Introduction

Unity Design Studio was commissioned by the Town of The Blue Mountains and the Blue Mountains Public Library to review the accessibility of the L.E Shore Memorial Library at 173 Bruce St South in Thornbury.

Parking & Building Approach

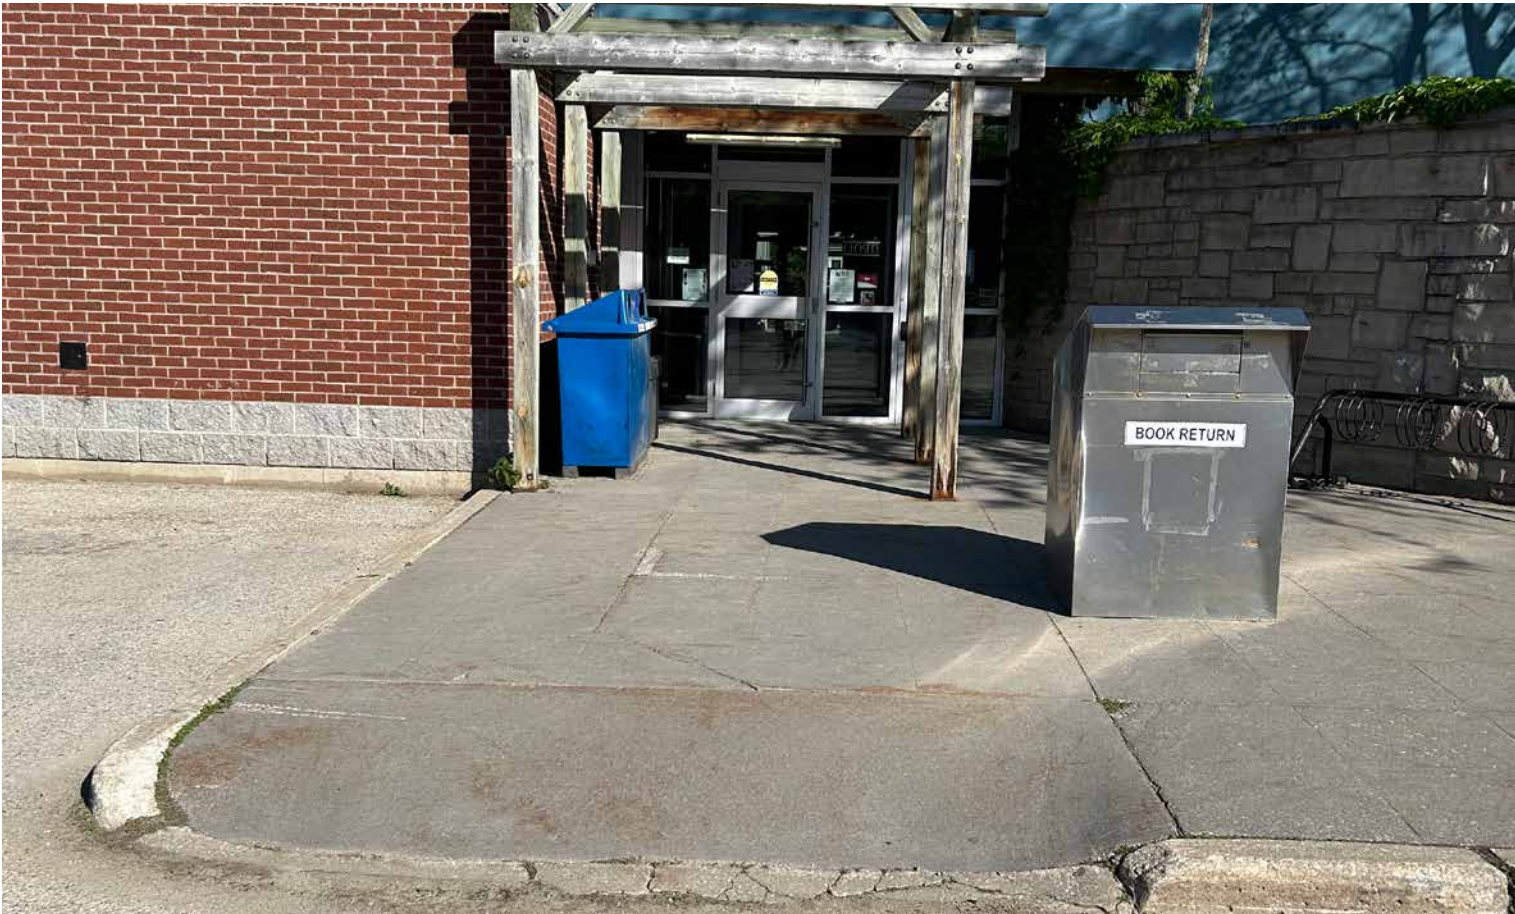
Obstacles along pathways leading up to the building can impede people with vision loss and make travel challenging for those using mobility devices.

Obstacles such as waste receptacles and the book return should be colour-contrasted with their surroundings and placed in amenity zones that have colour and textural contrast from the primary path of travel.

The door to the courtyard swings out into the path of travel, which is a safety hazard. It's currently marked by pylons, but the remaining space on the sidewalk is too narrow.

The door should swing inwards, be removed entirely, or the walkway could be widened and the door swing protected by a wall or cane-detectable guard.

Building Entrance

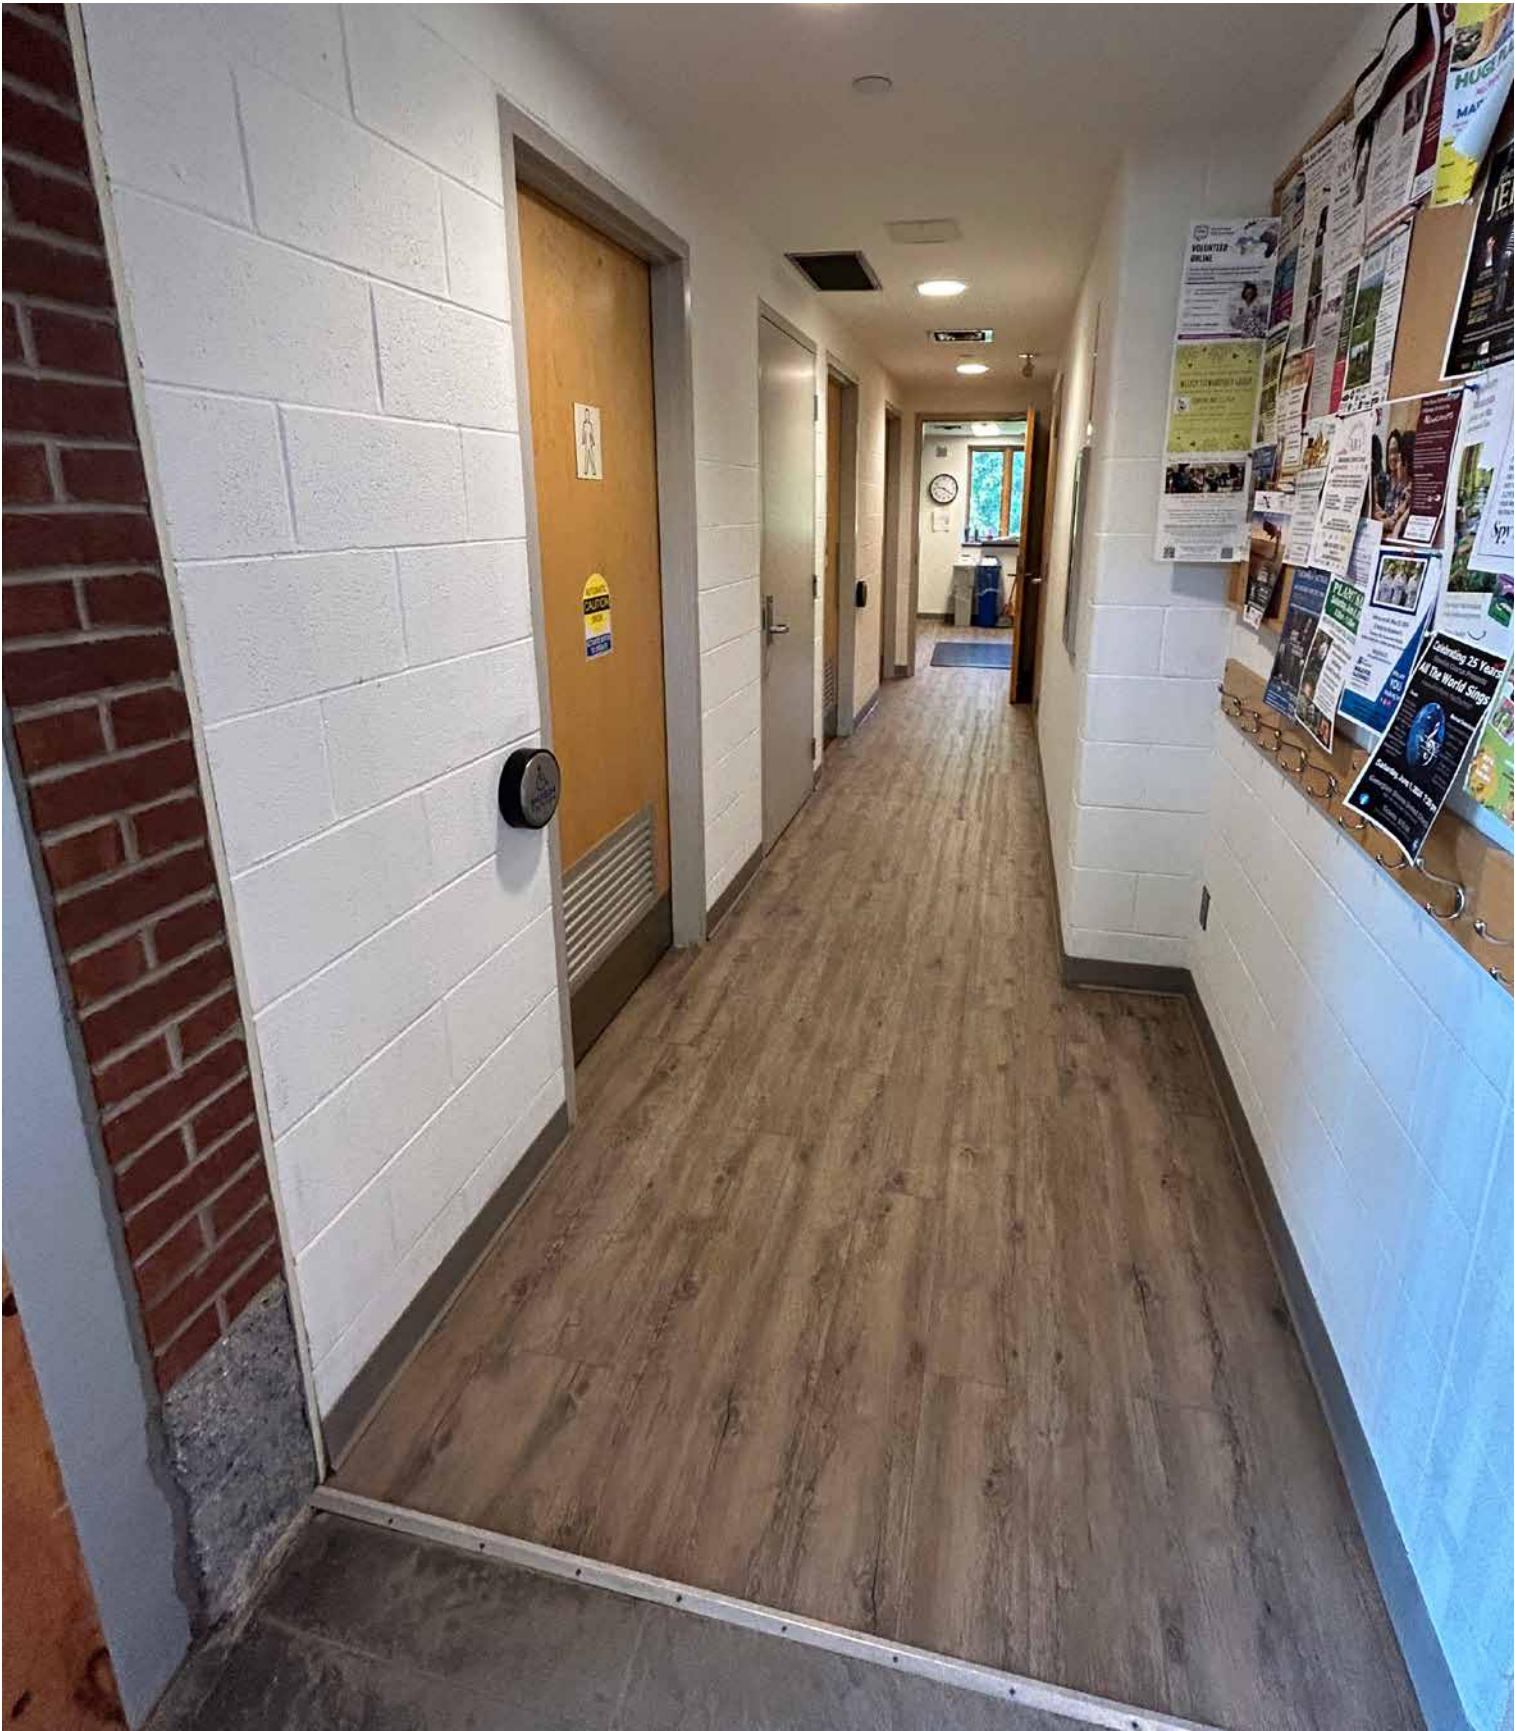
The entrance doors currently have a clear opening width of 850mm. Change the hinge style to swing-clear hinges to meet this minimum clear space. The threshold height between interior and exterior is excellent.

Glazing should have vision strips at two heights to ensure glazing is not mistaken for openings.

The entrance glazing has horizontal mullions, but best practice would be to add another contrast strip at a higher level.

The security access panel is mounted too high and too close to the wall – someone using a wheeled mobility device would not be able to access it.

It is also better for the device to contrast with its mounting surface so it can be more easily located by someone with low vision.

Kitchen

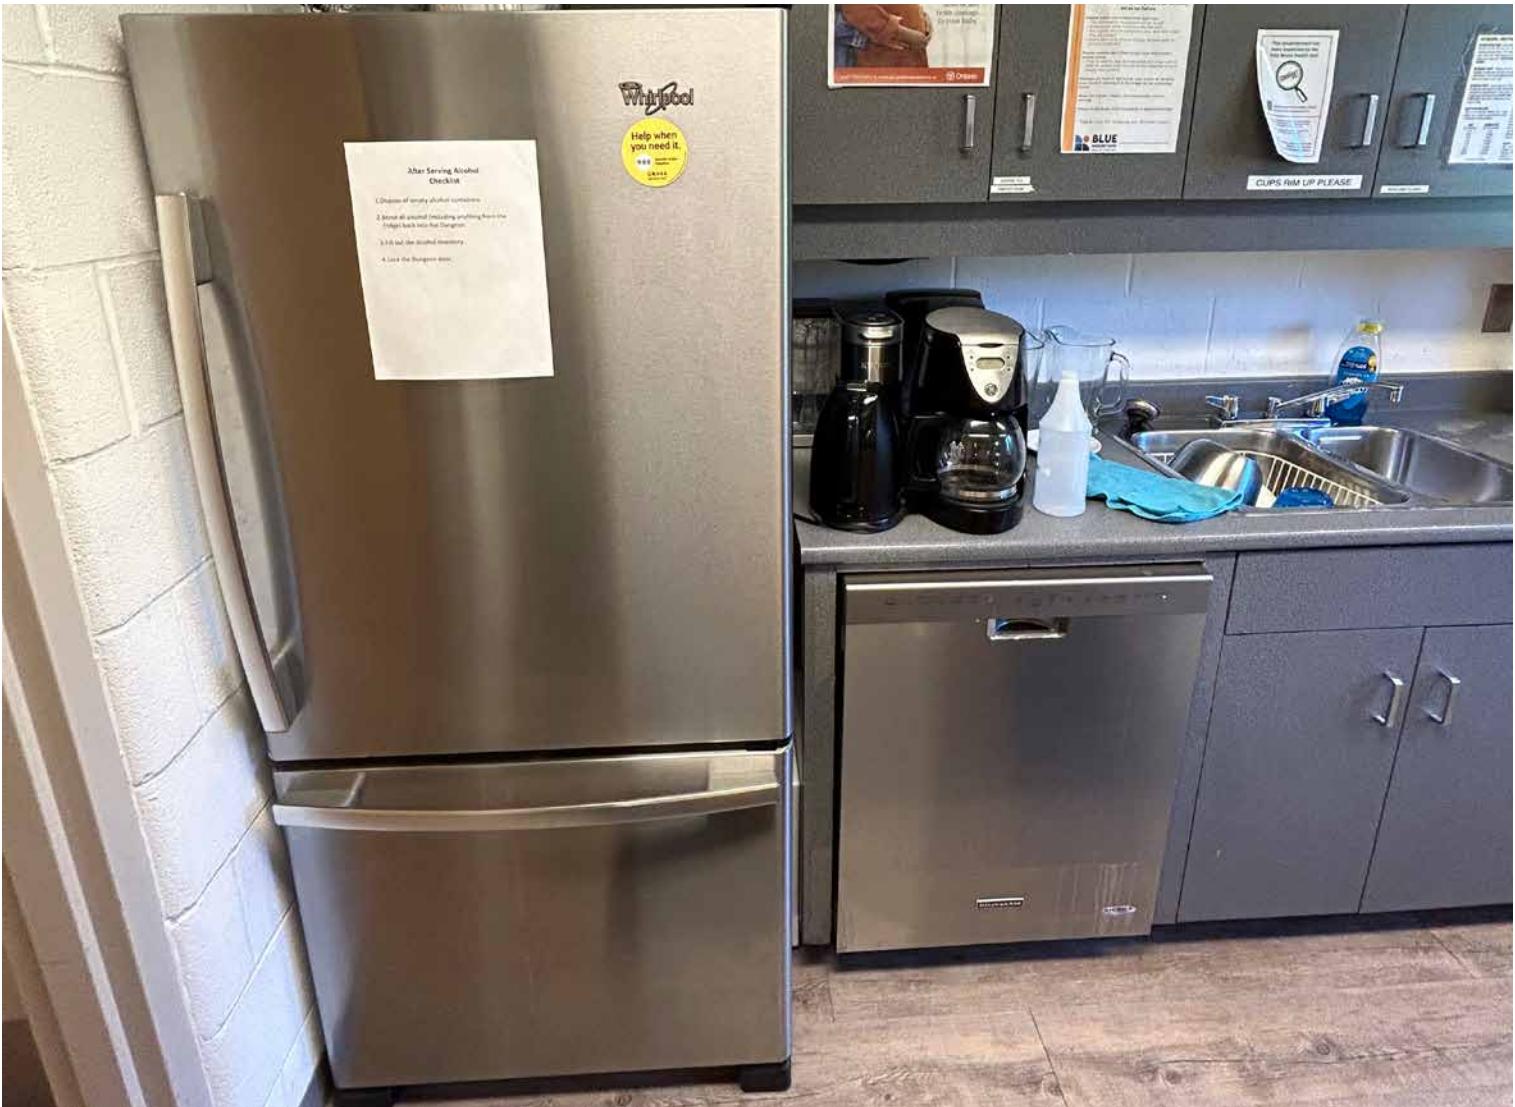
The bar height is too high for accessible use and people of short stature, it also has no knee space on the service side or the public side.

The style of the bottom drawer freezer fridge is good however the door swing on the fridge needs to open in the opposite direction to be accessible.

The undercounter fridge in the staff room cannot be opened with a closed fist.

Other Considerations

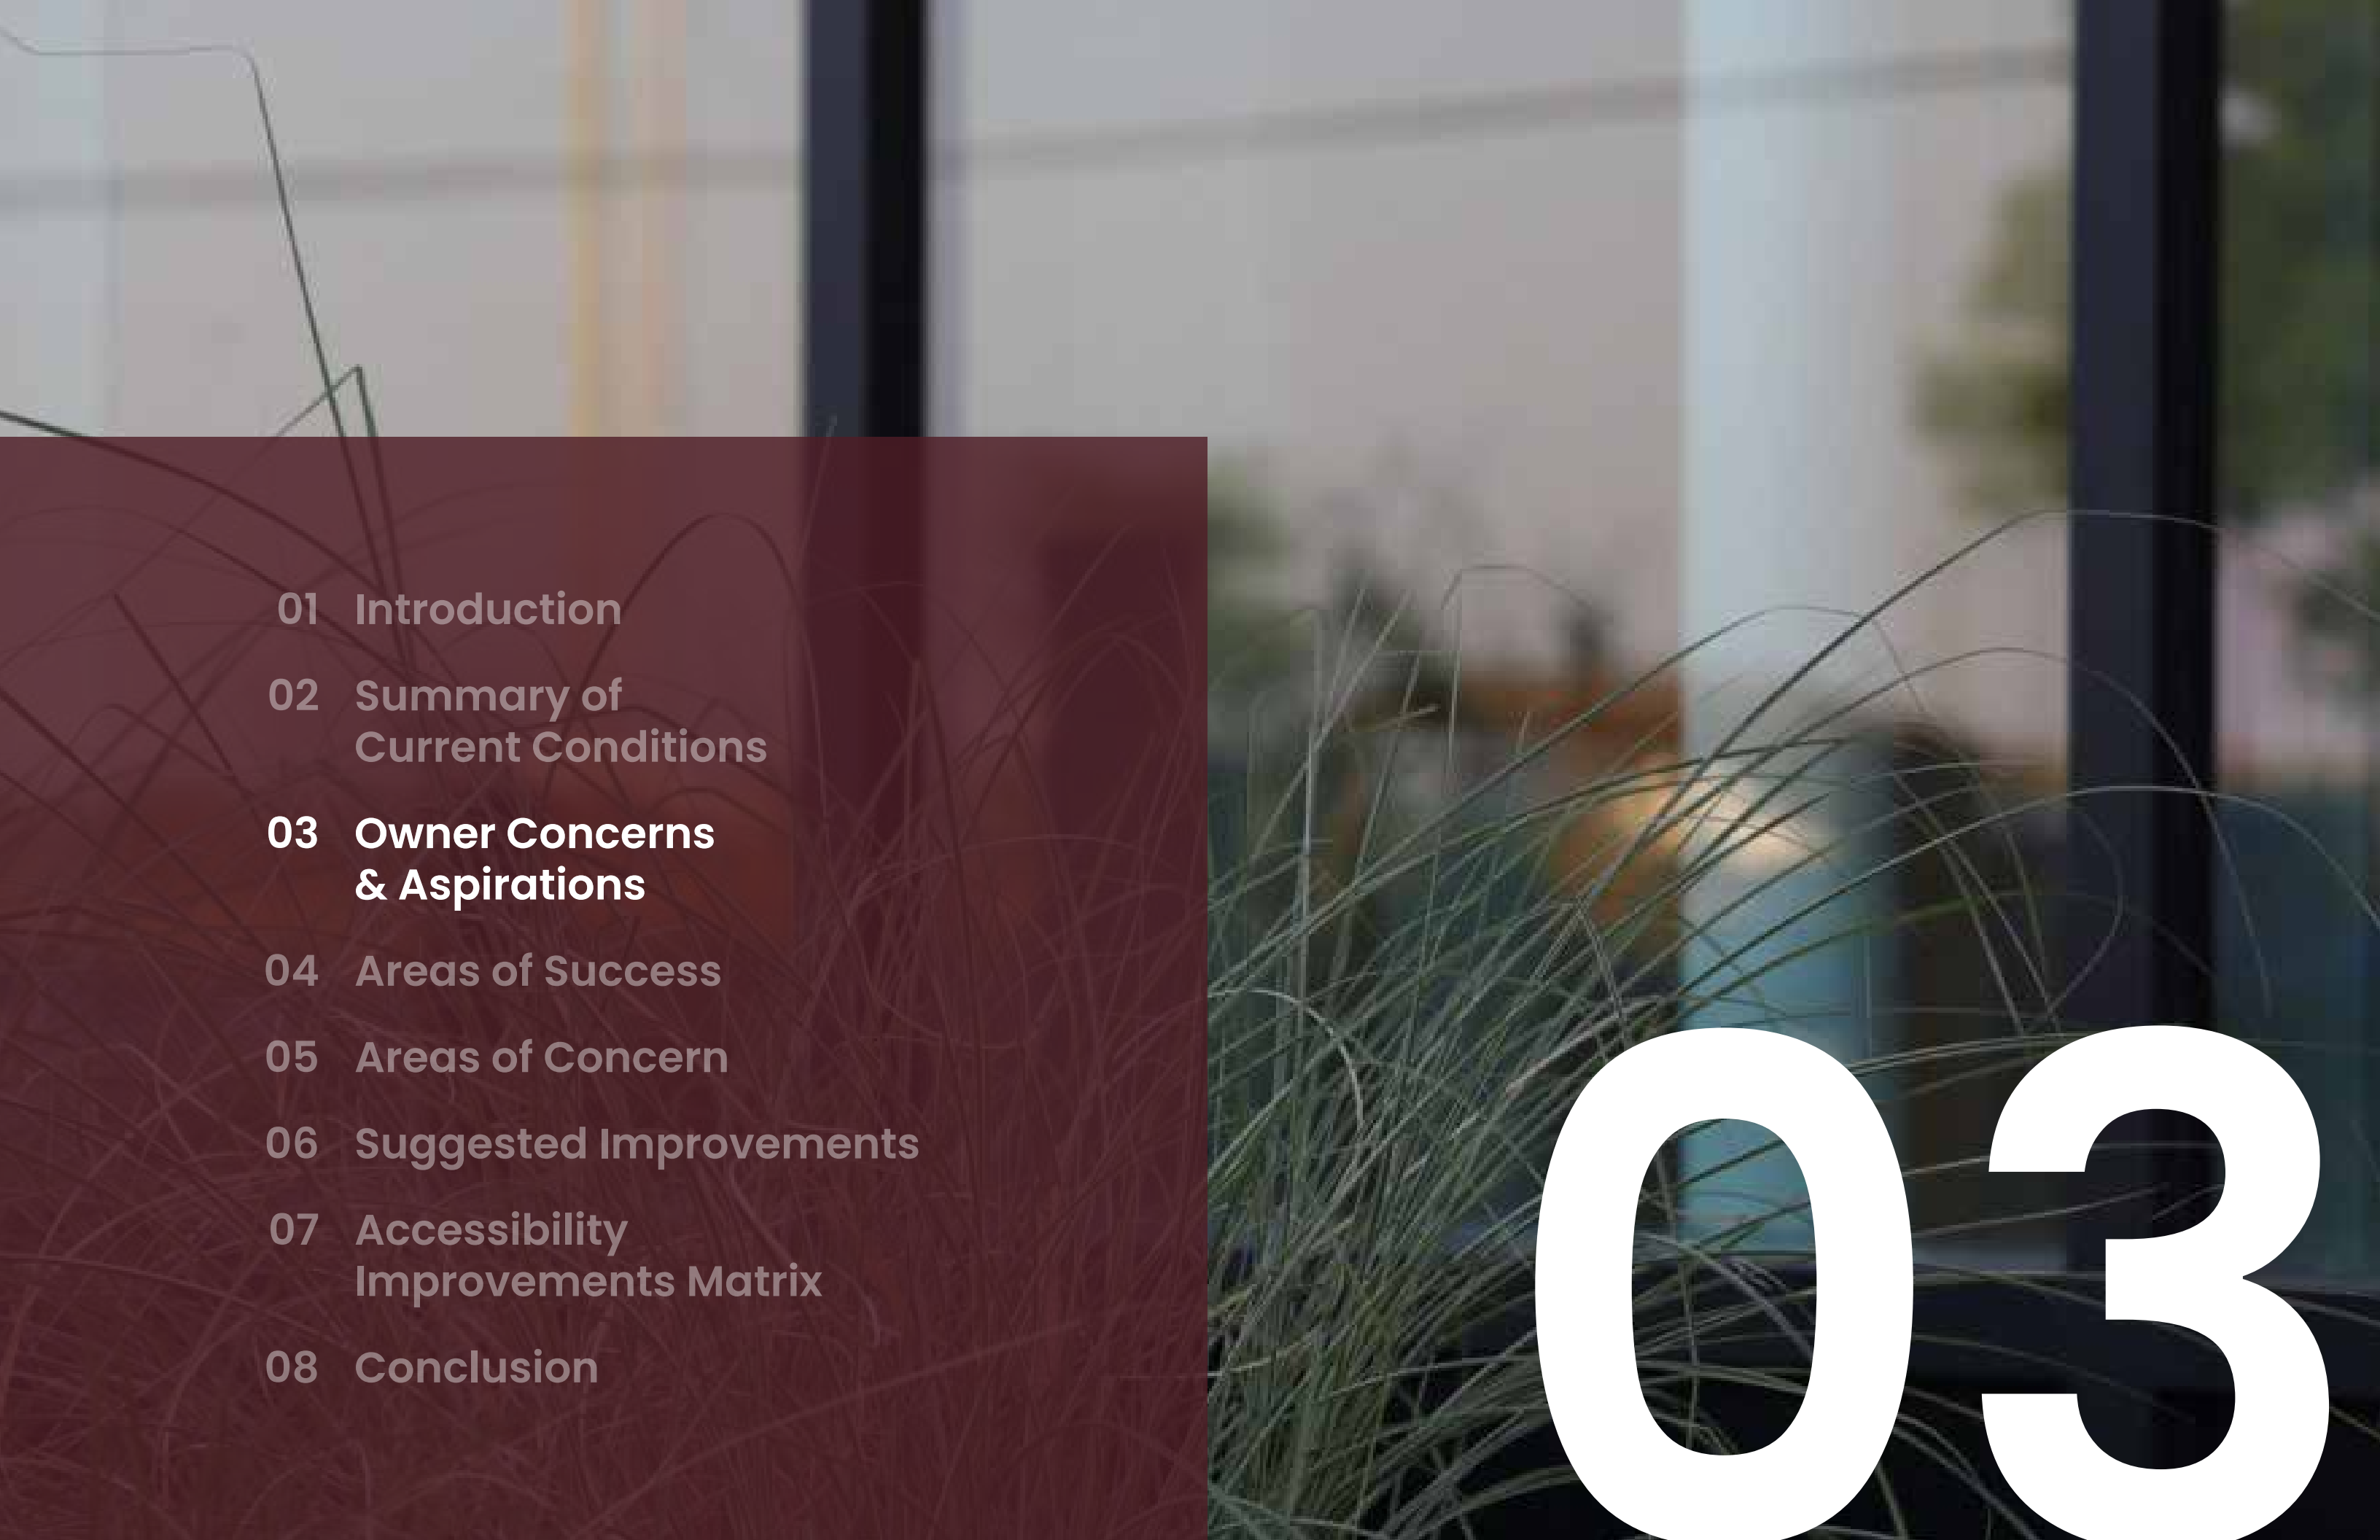
Thermostats are mounted outside of accessible reach and the touchscreen controls would not be usable by people with visual impairments.

Sun casting patterns or strongly patterned surfaces in the path of travel can be seen as physical obstacles for people with diverse neurological experiences.

It is recommended to change this to a model with physical buttons.

Where appropriate, glass can be replaced with insulated light diffusing glazing.
